SERVICETEKNOTES

TABLE OF CONTENTS

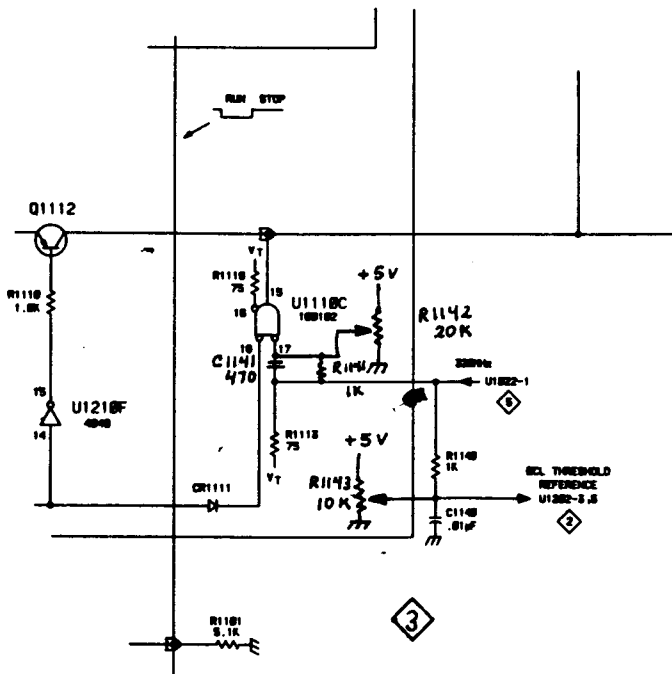
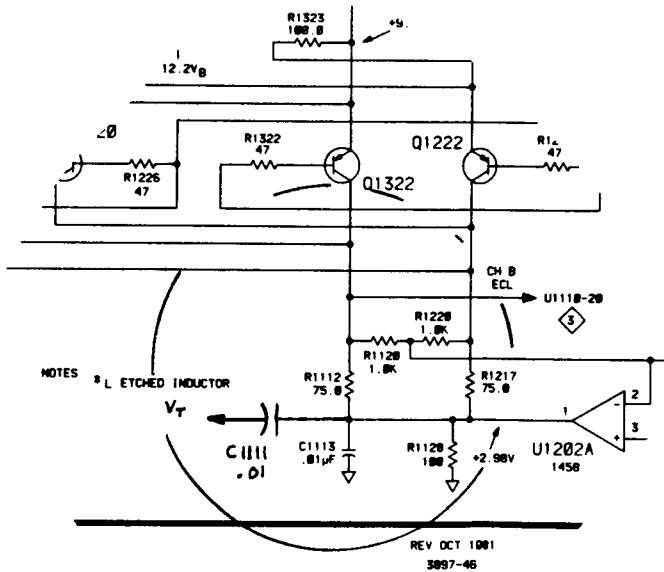
set up for U1001 and U1110. If U1001 or U1110 fails or the counter will not meet specifications and U1001 or U1110 is replaced, check that U1001 and U1110 are both the -04 part. This new part will ensure correct operation of the counter when both U1001 and U1110 are the -04 part. There must not be a mismatch of the -04 part combined with the -00 part.

The following changes must be made when adding the new parts:

1. Ensure U1110 pins 9 and 10 are shorted together and pins 21 and 22 are shorted together. Remove A12C1502.
2. Add A12C1111 P/N 283-0220-00 .01microfarad between A12R1112 and A12R1113 as shown on the diagram.
3. Add A12C1141 P/N 283-0315-00 in series with pin 17 of U1110.
4. Add A12R1141 P/N 317-0102-00 from the junction of pin 17 of U1110 and A12C1141 to R1113 as shown in the diagram.
5. Add A12R1142 P/N 311-0644-00 to U1110 with the wiper connected to pin 17 and the other leads connected one to the junction of pin 9 and 10, and the other lead connected to the junction of pin 21 and 22.
6. Add A12R1143 P/N 311-2102-00. The wiper lead connects to the empty hole next to the anode of CR1111 (see diagram) and connect the other two leads to C1114, one on each side.

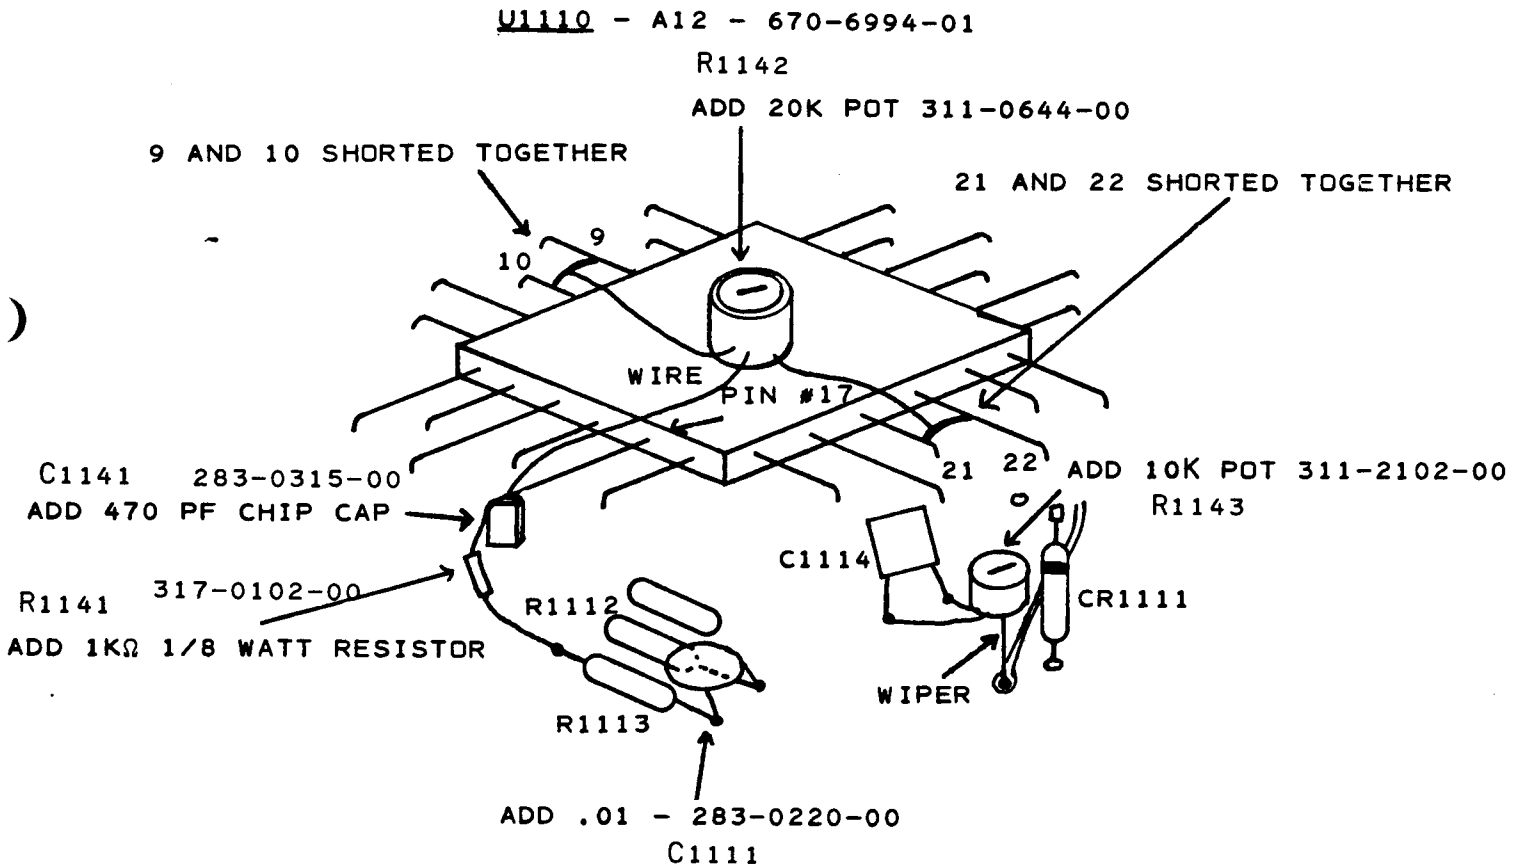
LIFT PIN #17 OF U1110 AND SOLDER 470 PF CHIP CAP (USING SILVER SOLDER) BETWEEN PIN #17 AND THE PAD ON THE BOARD.

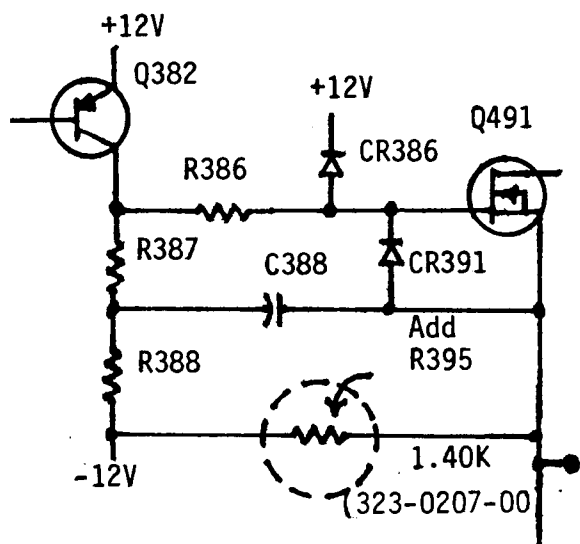
In order to get a better yield from some VMOS parts, they will be purchased with a 4.2 Vgs spec. The new part number for Q291, Q491 and Q691 will be 151-1143-01.

In order to have the circuit biased properly for these parts, a 1.4K Resistor (P/N 323-0207-00) needs to be added to each channel as shown in the figure below (Green channel shown).

A kit has been set up to accomplish this change when one of the affected transistors needs to be replaced. 050-1674-00 will supply one transistor to replace the failed part and three resistors to put into the circuit, one for each channel (Red, Green and Blue). Kit 050-1674-00 need only be ordered where a previous kit, 050-1582-00, has already been installed. Of course, once 050-1674-00 has been installed, you need order only the failed transistor replacement for that channel.

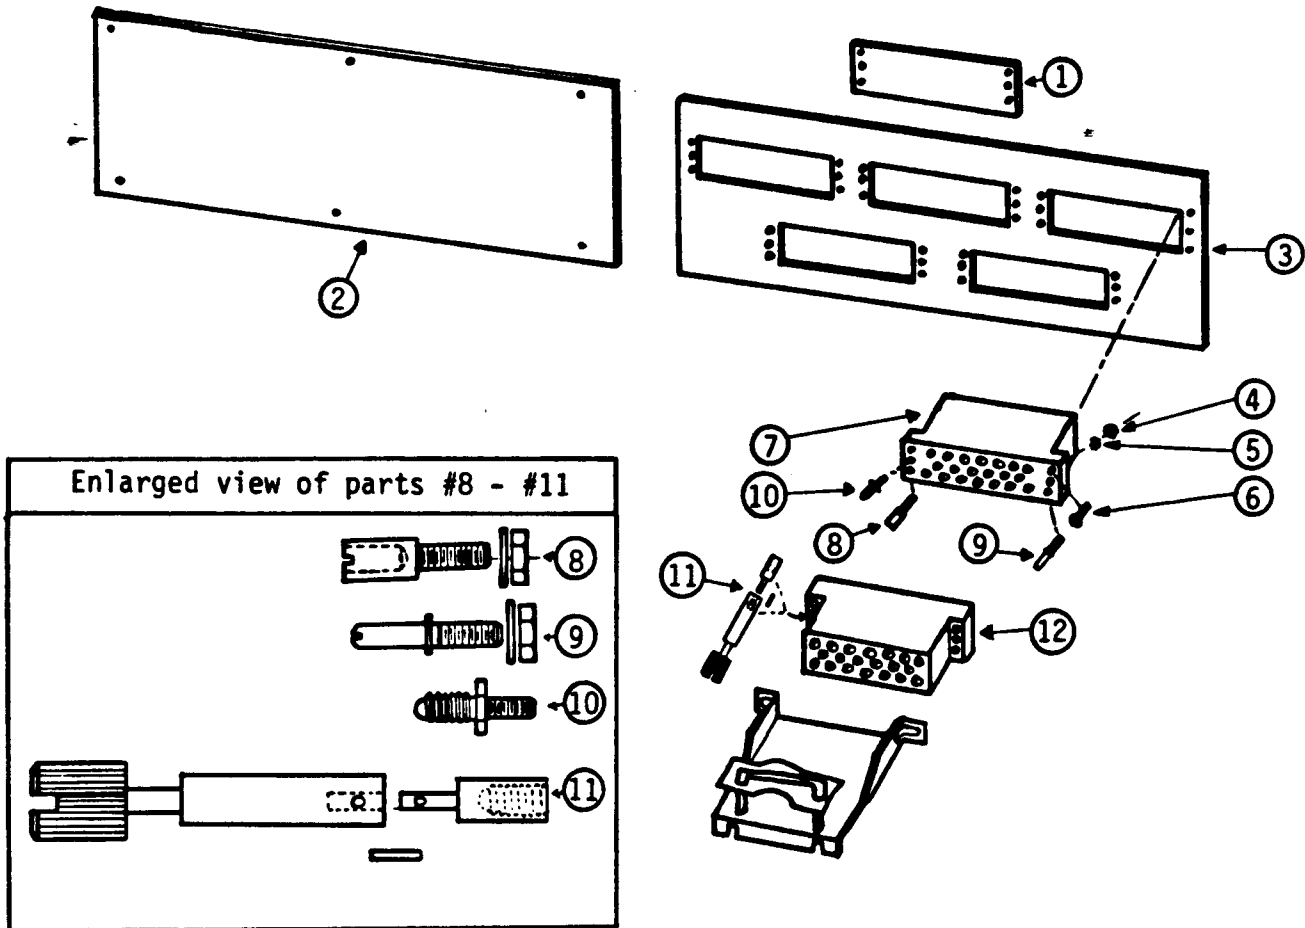
RE: P/N 040-1099-00
2213, SN B010100 - B025774
2215, SN B010100 - B025695
APPLICATION: AS REQUIRED,
ESPECIALLY USEFUL FOR TV
SIGNAL TRIGGERING

Mod kit 040-1099-00 is now orderable to improve the operation of the AUTO and TV FIELD trigger circuits. It improves triggering on Composite Video Sync pulses and on successive TV Fields in ALT mode. Holdoff time is reduced to decrease the trace flicker in ALT mode and increase display brightness.
